SH1/SH29 Intersection Upgrade Project – Response to further information request from Waikato Regional Council

Thank you for your letter dated 20 September 2021 requesting further information pursuant to section 92 of the Resource Management Act 1991 (RMA) in relation to Waka Kotahi's application for resource consents for the SH1/SH29 Intersection Upgrade Project (Project).

Figure 1 - Flow extraction at key watercourse locations (basemap shows 1 in 10 year ARI baseline scenario)

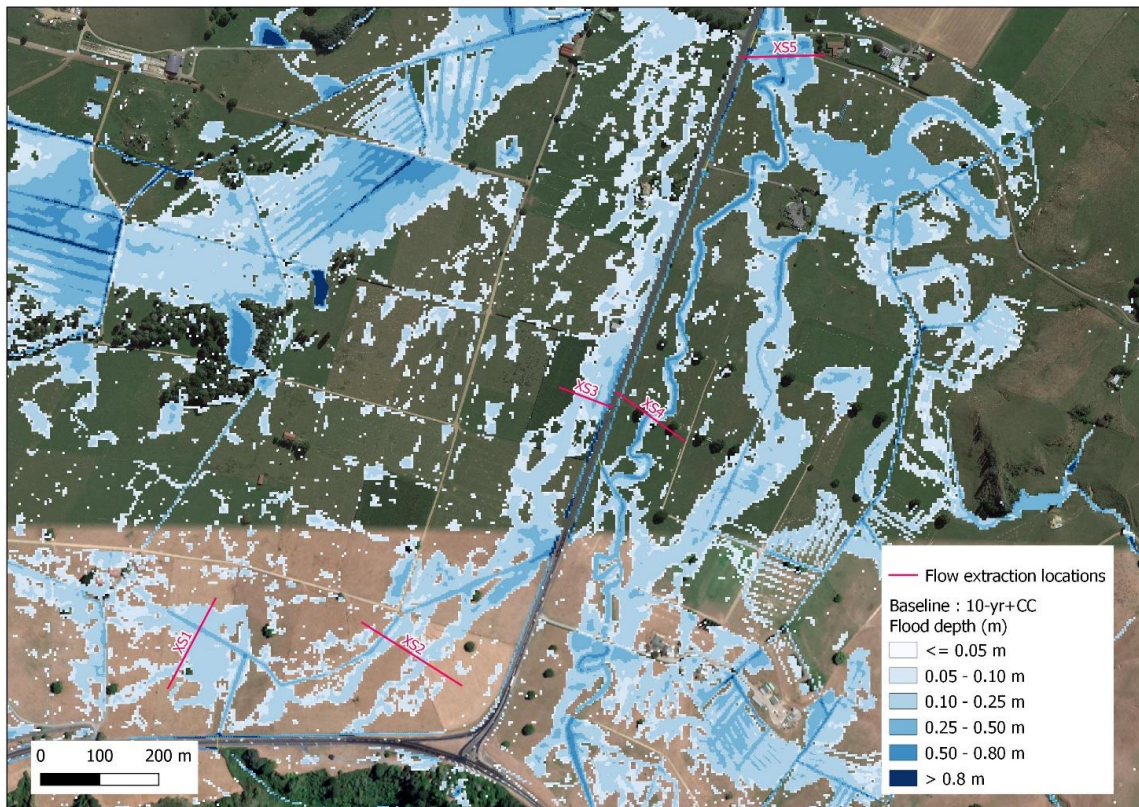
Please provide justification of why intermediate storm management is not required, specifically in this catchment. Further, please provide pre and post impervious area comparisons and peak flow comparisons at each discharge location for the 2 and 10-year ARI events.

Please refer to **Attachment B** to the letter which provides the pre and post peak flow comparisons for intermediate storm events at the discharge locations shown in Figure 1 below.

In most instances, the change in flow is negligible. There are minor increases in peak flow for the 1 in 2 year ARI event at XS2 and XS3 however the flow velocities remain well below the erosive threshold as shown in Figure 4-7 of the Stormwater Assessment Report.

Figure 2 - Change in flood extent and depth at Culvert 2 for the 1 in 50-year ARI storm

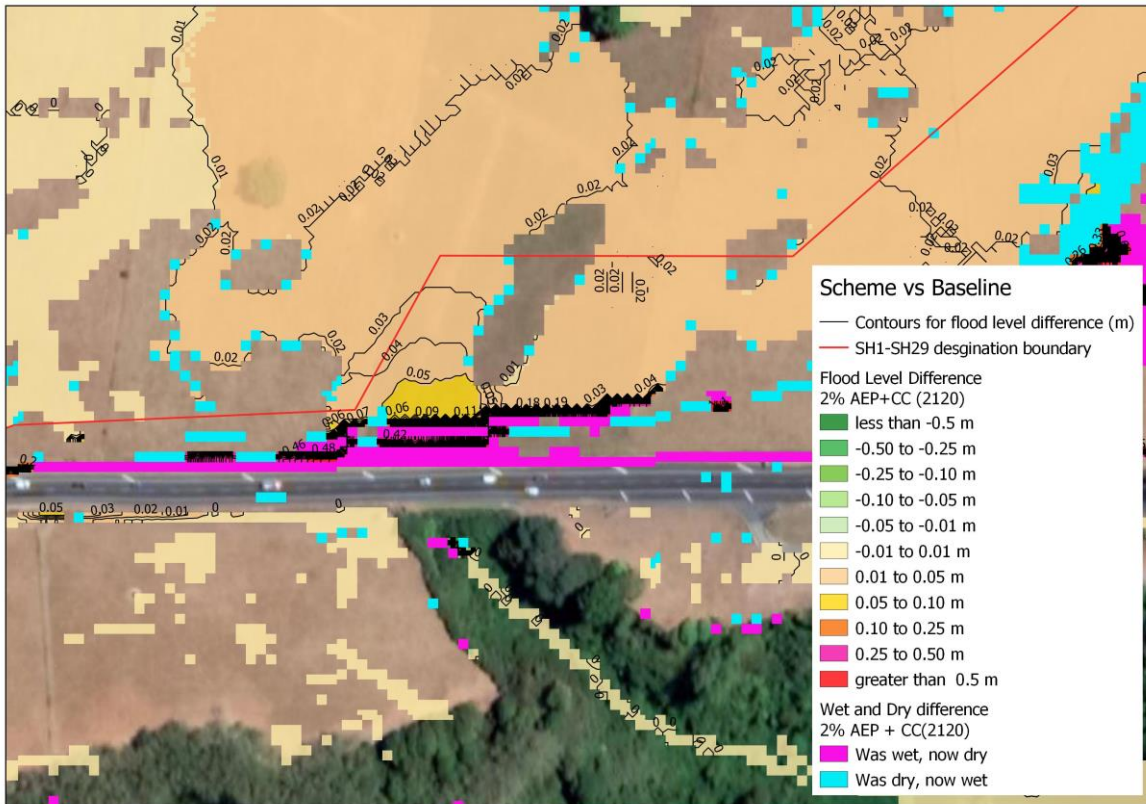
proposed to be removed under SH1 North (Karapiro Leg). To mitigate the increase flooding it is proposed to undertake minor filling in land outside the designation to remove the flood effects. The report mentions if this is not suitable then alternative pipe options are available. Given the land in question hasn't been able to be accessed and no detailed survey has been undertaken of levels, there is concern that the effects of removing this culvert could be worse than presented in the report.

If the 450mm culvert is to be removed, please provide further detailed topographic survey to define the extent of the catchment and fall of the drains. Please also include a plan to show the extent of the fill required on the adjacent land and confirm whether permission from the landowner has been obtained for this to occur. If approval has been obtained, please provide a copy. Alternatively, please provide more detail of the alternative pipe options discussed in the report.

The hydraulic model shows that the increase of flood depth in the 1 in 50-year event, that is ≤ 40 mm from the baseline, lasts for a duration of less than 1 hour. Given the rural context i.e. open pastoral land clear from any structures, the impact of the increased flood depth for a duration of less than 1 hour on a small section of land is a potential transitory flooding effect that is considered to be de minimis. Therefore, the removal of Culvert 02 can be considered a permitted activity under Rule 4.2.5.1 of the Waikato Regional Plan.

Given the minimal effect, mitigation by earth filling is not considered to be warranted. As such, no plan or written approval from the landowner is required.
